PECOS DISTRICT CONDITIONS OF APPROVAL

OPERATOR'S NAME:	Devon Energy Production Company, L.P.
LEASE NO.:	NMLC-063798
WELL NAME & NO.:	Boomslang 14 Fed 2H
SURFACE HOLE FOOTAGE:	0200' FNL & 1932' FWL
BOTTOM HOLE FOOTAGE	0330' FSL & 1932' FWL
LOCATION:	Section 14, T. 24 S., R 33 E., NMPM
COUNTY:	Lea County, New Mexico

Figure 1. Cross-sections and plans for typical road sections representative of BLM resource or FS local and higher-class roads.

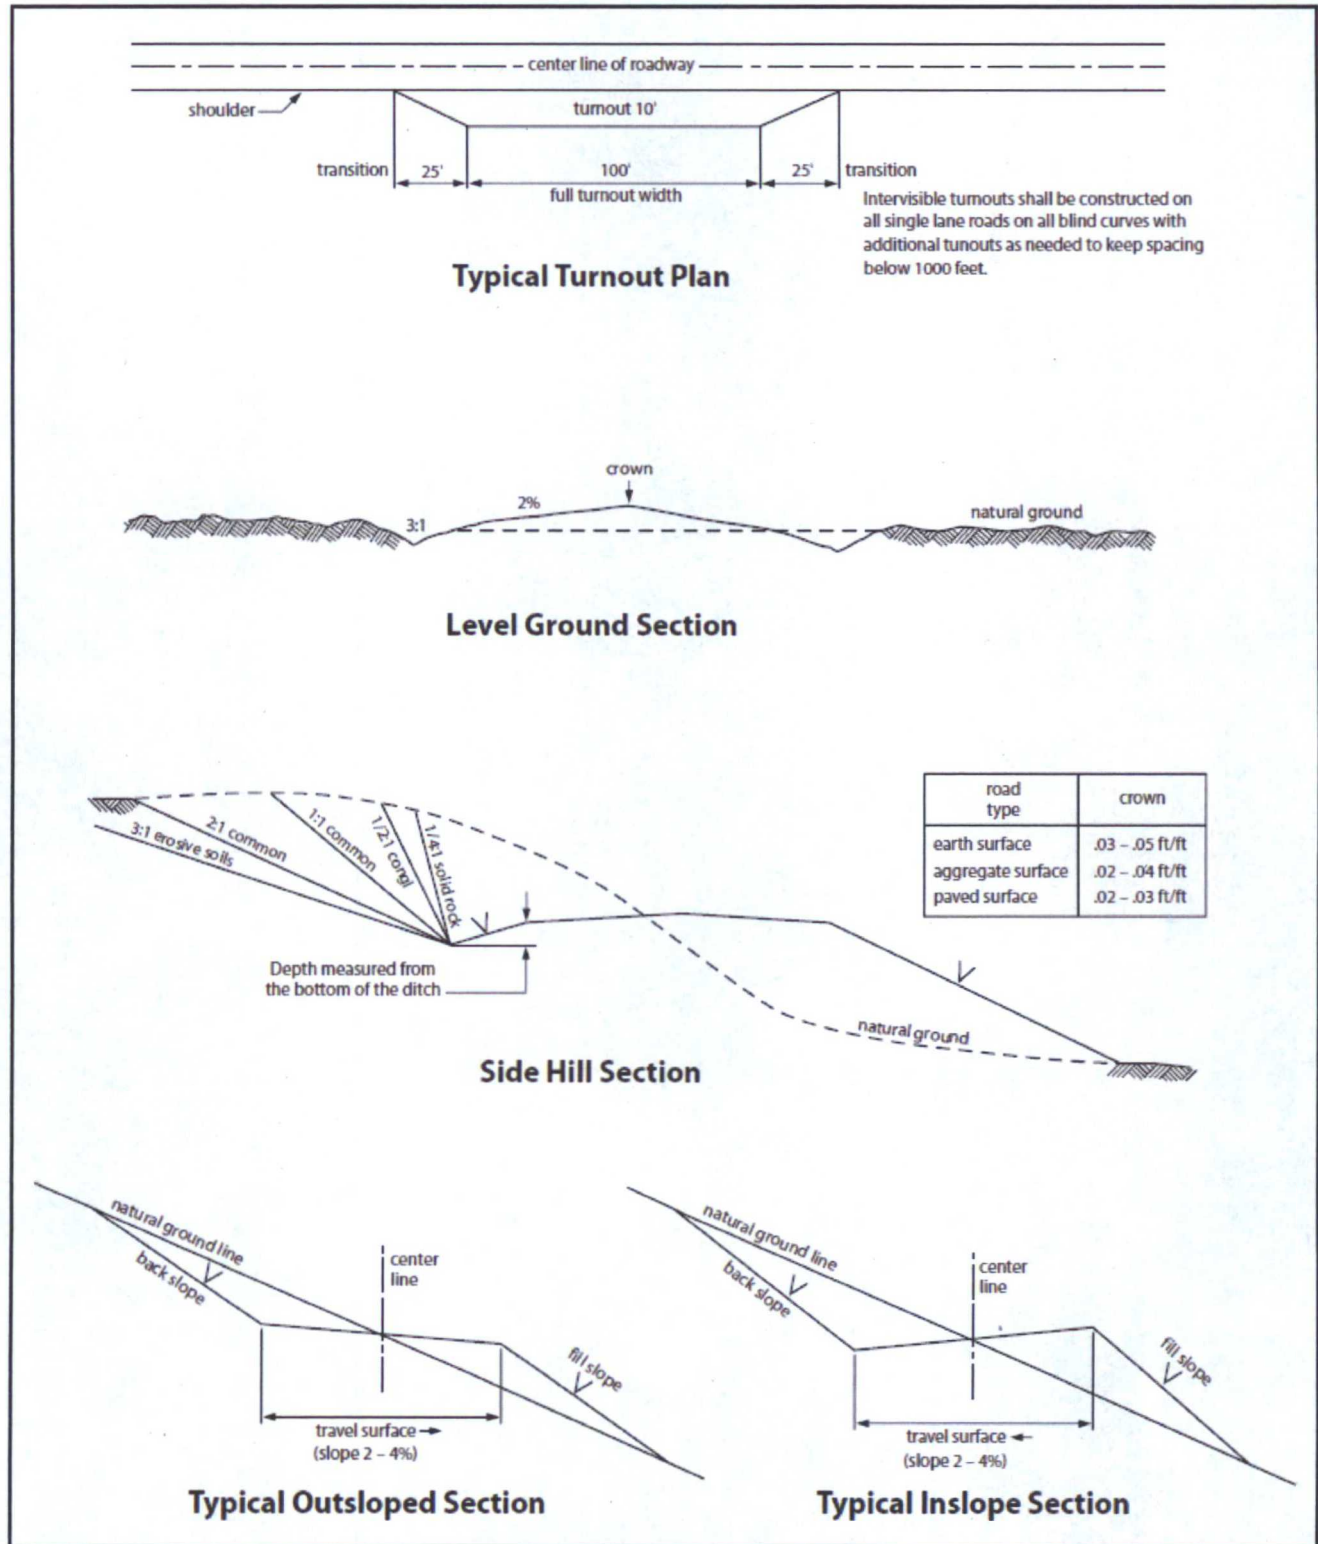
Crowning shall be done on the access road driving surface. The road crown shall have a grade of approximately 2% (i.e., a 1" crown on a 14' wide road). The road shall conform to Figure 1; cross section and plans for typical road construction.

Vehicle turnouts shall be constructed on the road. Turnouts shall be intervisible with interval spacing distance less than 1000 feet. Turnouts shall conform to Figure 1; cross section and plans for typical road construction.
